**TOWN OF PLYMOUTH
PLYMOUTH MUNICIPAL AIRPORT**

CONSTRUCT, MARK, AND LIGHT TAXIWAY 'E' EXTENSION (APPROX. 500' X 35')

ADDENDUM No. 3

Date: December 22, 2020

M1.1

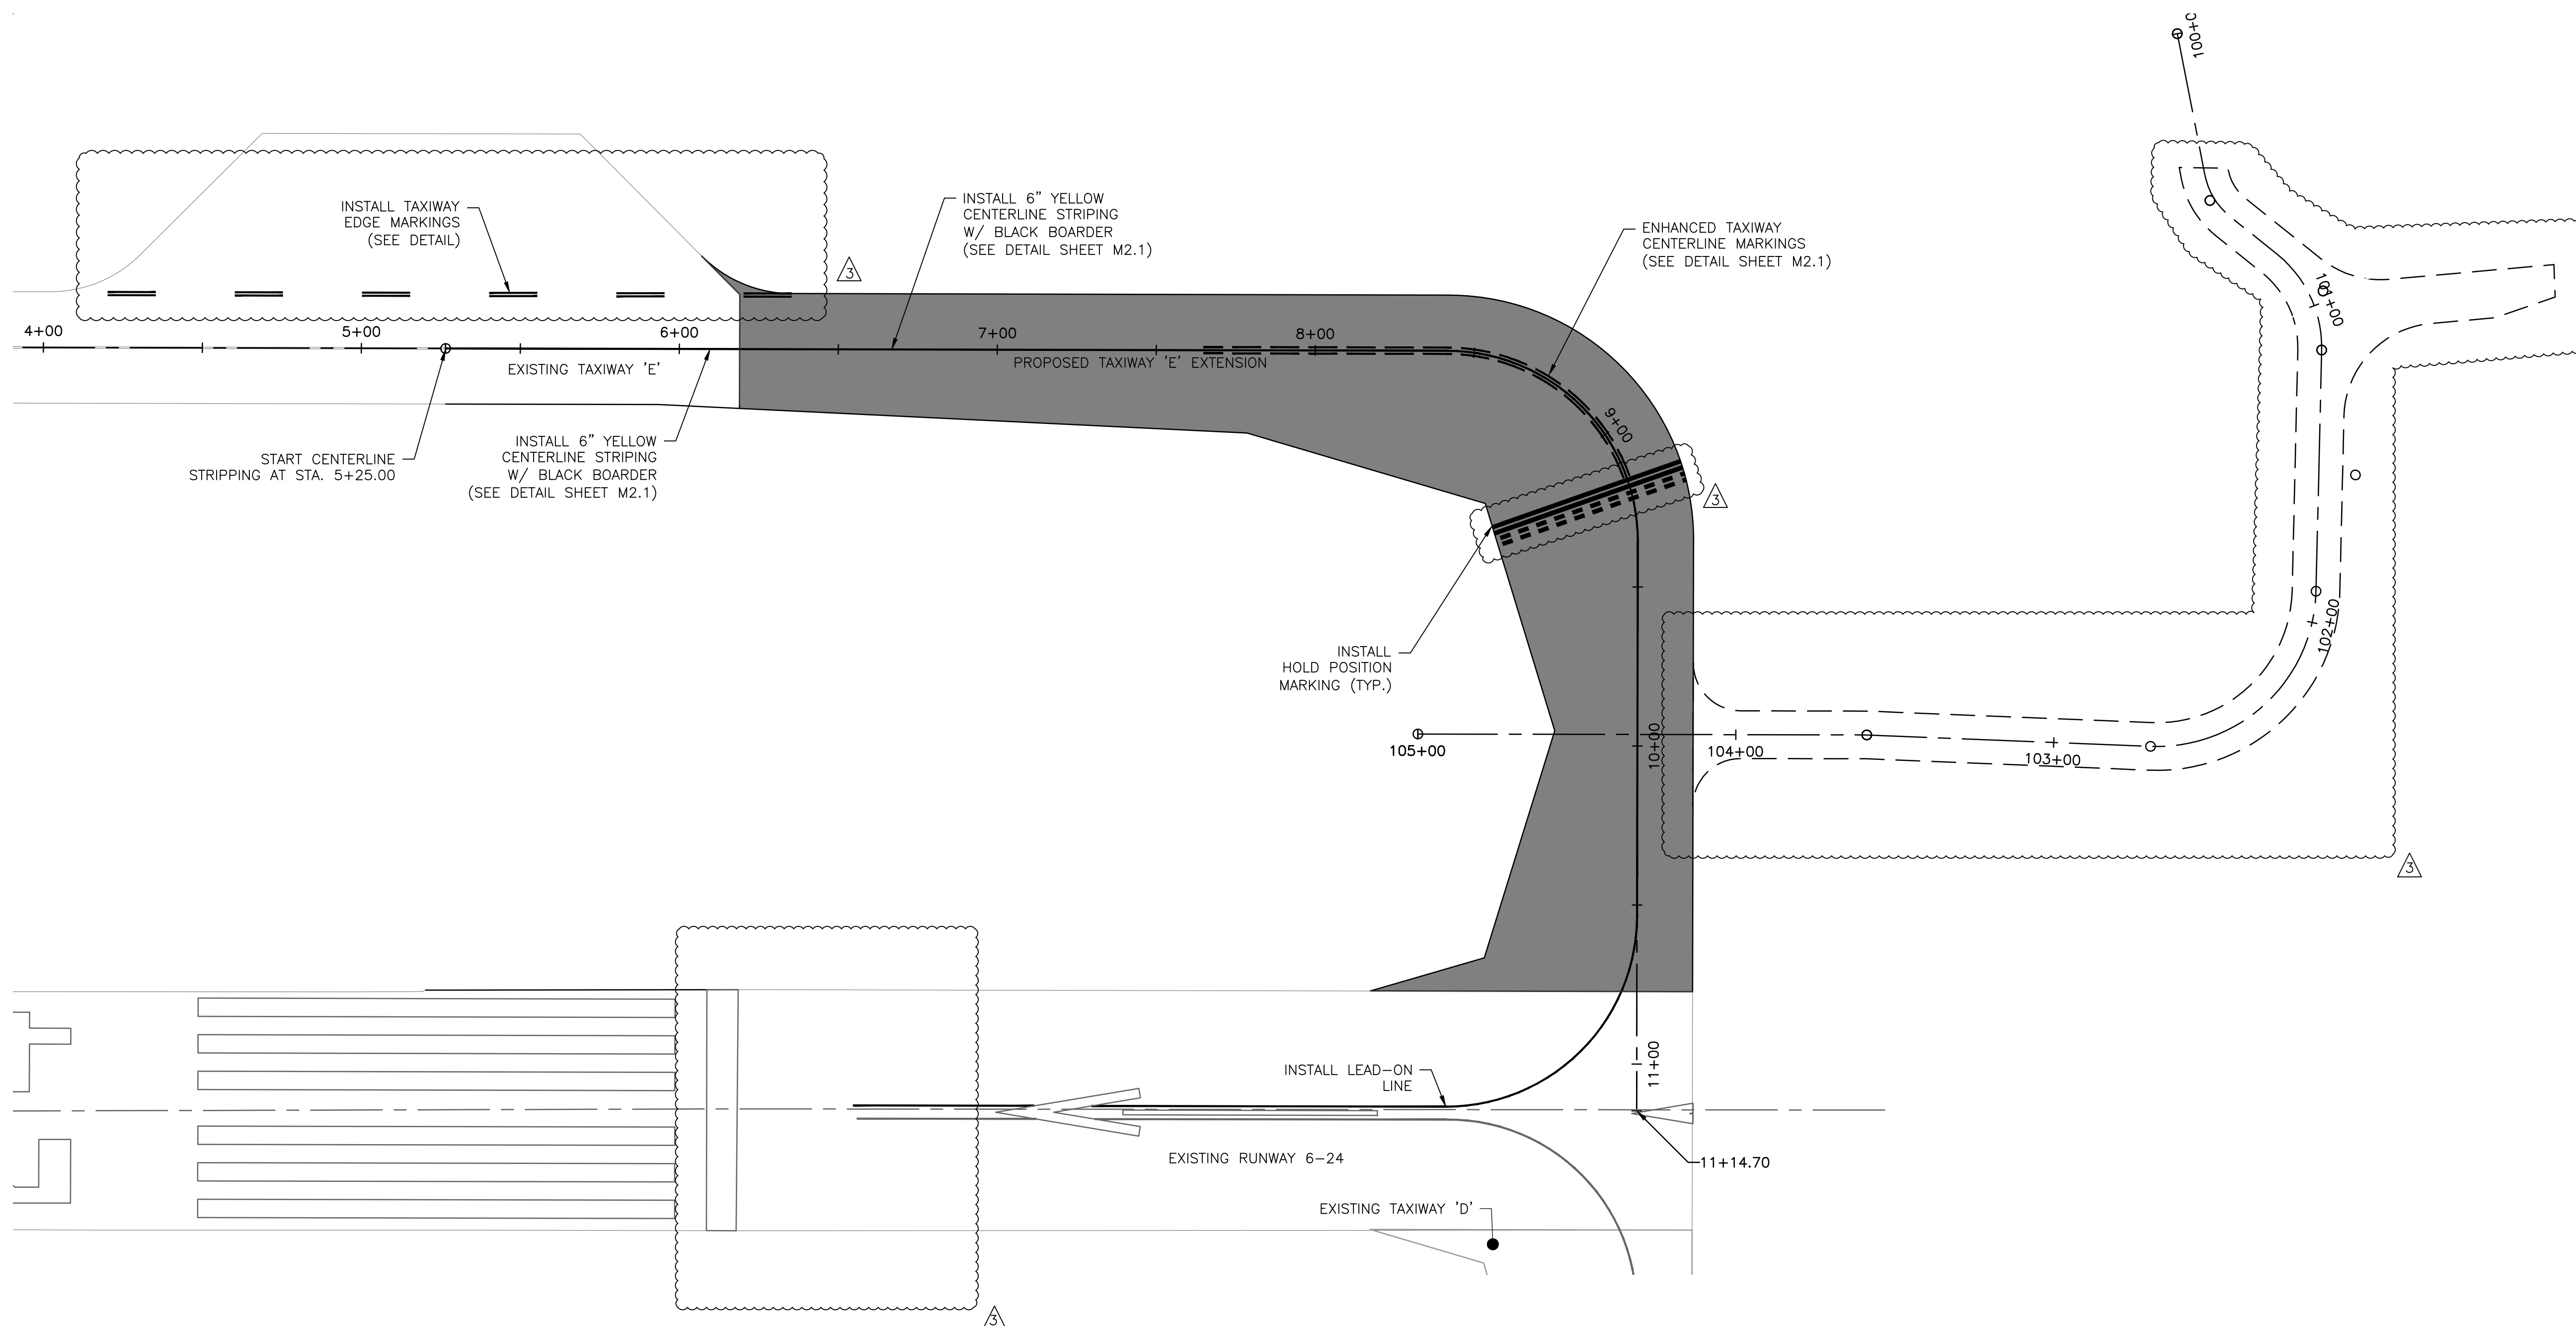
13. Drawing L2.2 has been revised to show the revised sign schedule, and remove the vehicle service road metal sign, which has been removed from the project.
14. Drawing M1.1 has been revised to show the new taxiway edge markings and modified centerline striping at the runup apron.
15. Drawing M2.1 has been revised to show the new taxiway edge marking detail for the runup apron, and remove the ILS hold line marking.
